UNITED STATES PATENT AND TRADEMARK OFFICE

Office Action Summary

09/836,351

YOO ET AL.

FIG. 11

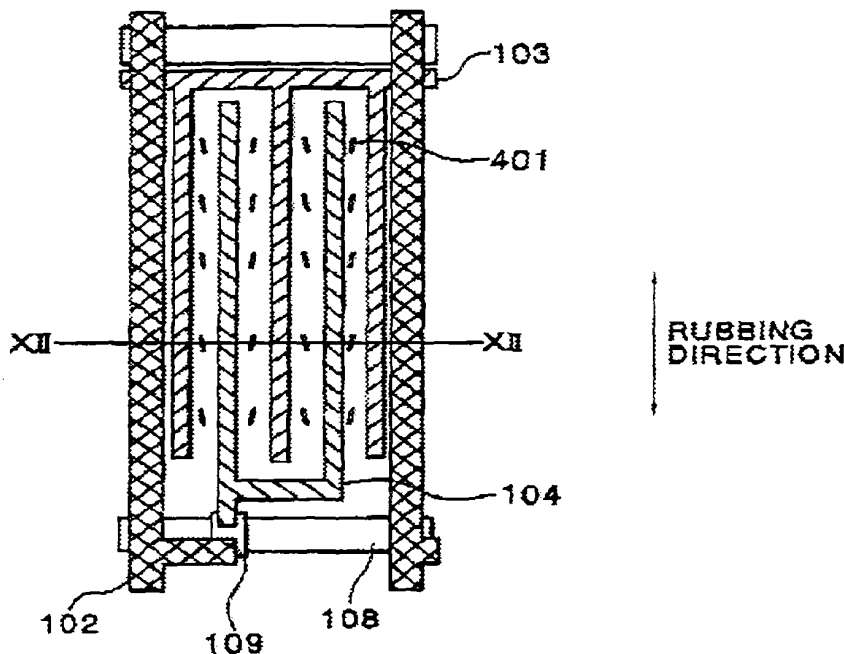
As to claim 1, Watanabe discloses in the first embodiment (col. 5, line 51 through col. 8, line 5 and Figures 11, 12, and 16), an IPS-LCD device, comprising: first, 101, and second, 201, substrates opposing each other; a scanning (Applicant's gate) line, 108, on the first substrate; a signal (Applicant's data) line, 102, perpendicular to the gate line; a thin film transistor, 109, at a crossing portion between the gate and data lines; a

common electrode (portion running left to right in Figure 11, Applicant's common line), 103, parallel to the gate line; a plurality of common electrodes (portions running top to bottom in Figure 11), 103, electrically connected to the common line, wherein the common electrodes are spaced apart from each other; a plurality of pixel electrodes, 104, alternately arranged with the plurality of common electrodes, wherein each pixel electrode is spaced apart from an adjacent common electrode; a plurality of insulator films, 105 and 106 (wherein 105 above common electrodes 103 is Applicant's gate-insulating layer and 106 above data line 102 is Applicant's passivation layer) (wherein 106 above the center common electrode of multiple pixels are Applicant's dielectric protrusions), between the first and second substrates; and a liquid crystal layer, 301, between the first and second substrates, wherein the liquid crystal layer and the dielectric protrusion have different dielectric constants as evidenced by Figure 16 and Table 2 (col. 7, lines 31-42).

FIG. 12

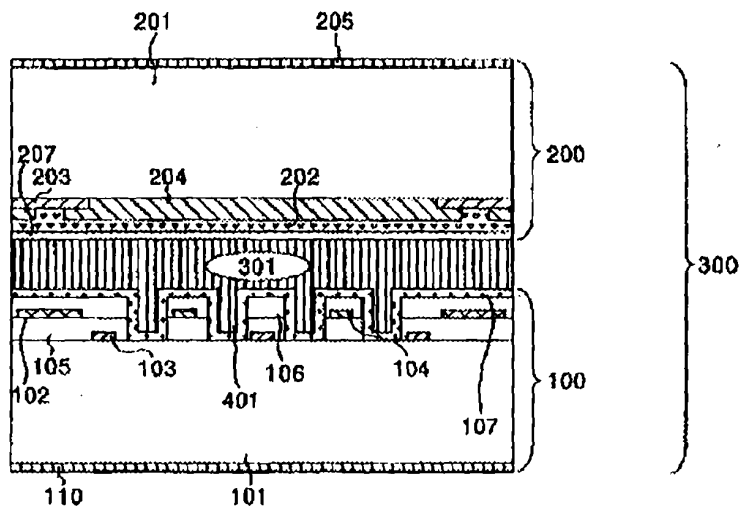
Please note that the insulating films (106 above the center common electrode of multiple pixels) do protrude into the liquid crystal material per Watanabe, Figure 12, and they do distort the electric field per Figure 16.

FIG. 12B

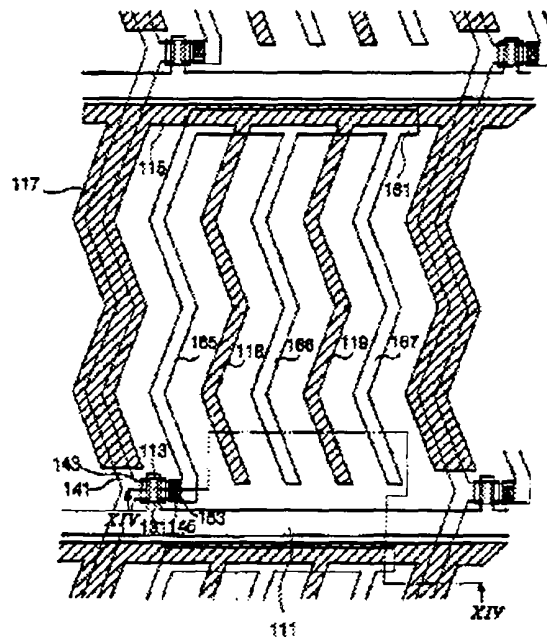
Kawano teaches the use of Al for pixel electrodes and opposite electrodes (Applicant's common electrodes) (col. 15, lines 38-44) in an in-plane switched (IPS) LCD that may optionally be made of ITO.

FIG.2

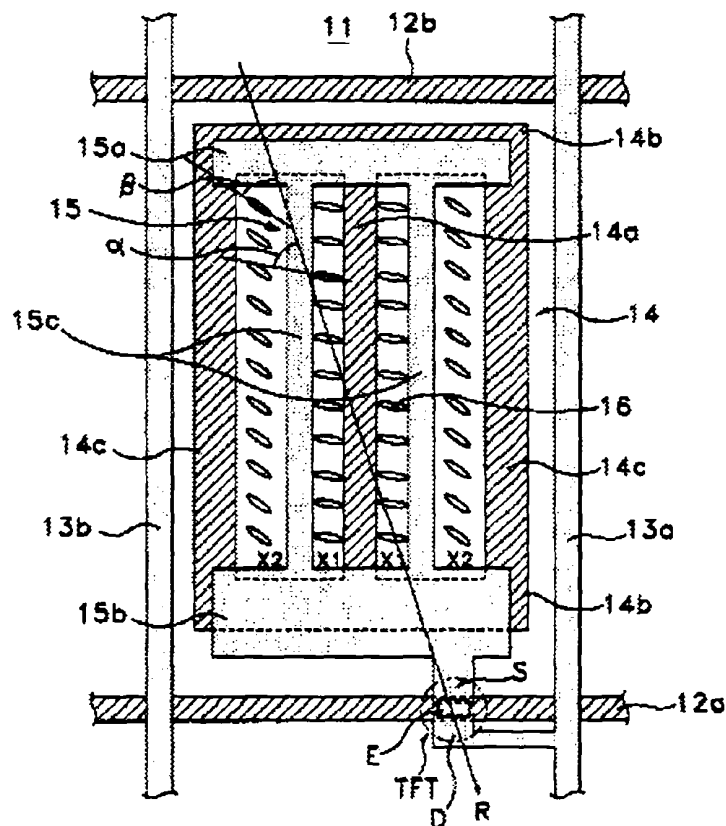
Lee teaches in Figure 2 an IPS LCD with negative or positive dielectric anisotropy (col. 2, lines 25-26), and Lee teaches the rubbing direction is changed to be

compatible with the anisotropic characteristics of the liquid crystal material (col. 3, lines 47-65) to achieve proper switching of the liquid crystal material. Note that some of the angles are improperly expressed, however, one of ordinary skill in the art of liquid crystals would understand that the LC molecules of negative dielectric anisotropy are aligned substantially perpendicular to the electrodes in the off state.
